Model: T-G1W	Date: 07-Aug-07	No.: RJ016001a
--------------	-----------------	----------------

Subject: Firmware Release History		Prepared by: Gimpei Hirao	
From: 1st Tech. Support Sec. Service Support Dept.			
Classification:	<input type="checkbox"/> Troubleshooting	<input type="checkbox"/> Part information	<input type="checkbox"/> Action required
	<input type="checkbox"/> Mechanical	<input type="checkbox"/> Electrical	<input type="checkbox"/> Service manual revision
	<input type="checkbox"/> Paper path	<input type="checkbox"/> Transmit/receive	<input type="checkbox"/> Retrofit information
	<input type="checkbox"/> Product Safety	<input checked="" type="checkbox"/> Other ()

Model: T-G1s / T-G1W		Date: 13-May-08	No.: RJ016005
Subject: Service Manual Revision		Prepared by: Y.Murata	
From: 1st Tech. Support Sec. Service Support Dept.			
Classification:	<input type="checkbox"/> Troubleshooting <input type="checkbox"/> Part information <input type="checkbox"/> Action required <input type="checkbox"/> Mechanical <input type="checkbox"/> Electrical <input checked="" type="checkbox"/> Service manual revision <input type="checkbox"/> Paper path <input type="checkbox"/> Transmit/receive <i

Changes made to the rack and side fences:**Rack: Side Fence**

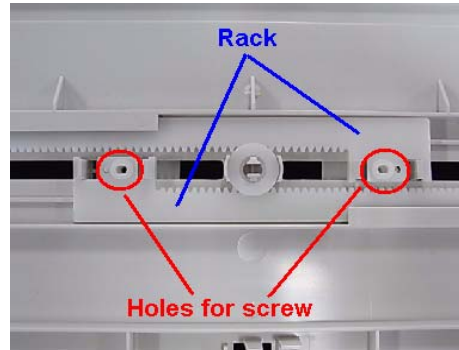
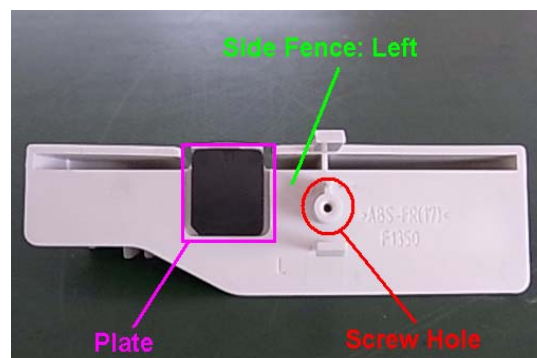
- 1) The shapes of the side fences and side fence rack were changed (see details on the next page).
- 2) A plate was added for the **left** side fence.

Screw holes were added.

A screw hole and a plate were added.

Only a screw hole was added (a plate was not added).

To hold the side fences in place more strongly while the machine is printing (which will minimize image skew).

If you need to replace the parts on machines produced before the cut-in S/N, install the following **together as a set**:

- **Right** side: Side fence and rack
- **Left** side: Side fence, rack, and plate

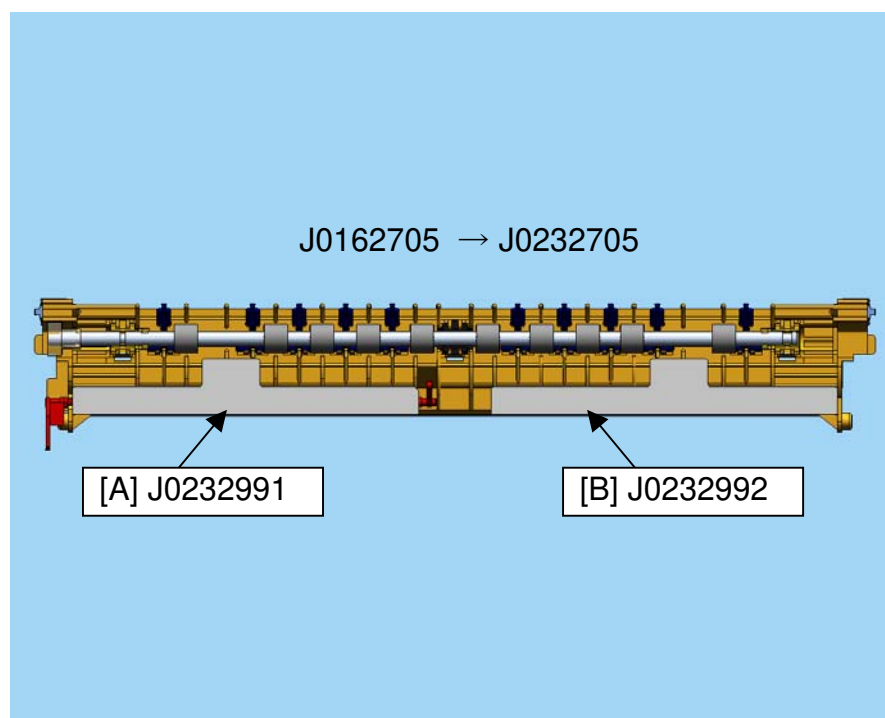
- 1) The shape of the Left Guide Sheet [A] was changed.
- 2) The Right Guide Sheet [B] was added.

Reason: To further ensure that paper is fed straight and does not crease around the reverse guide area.
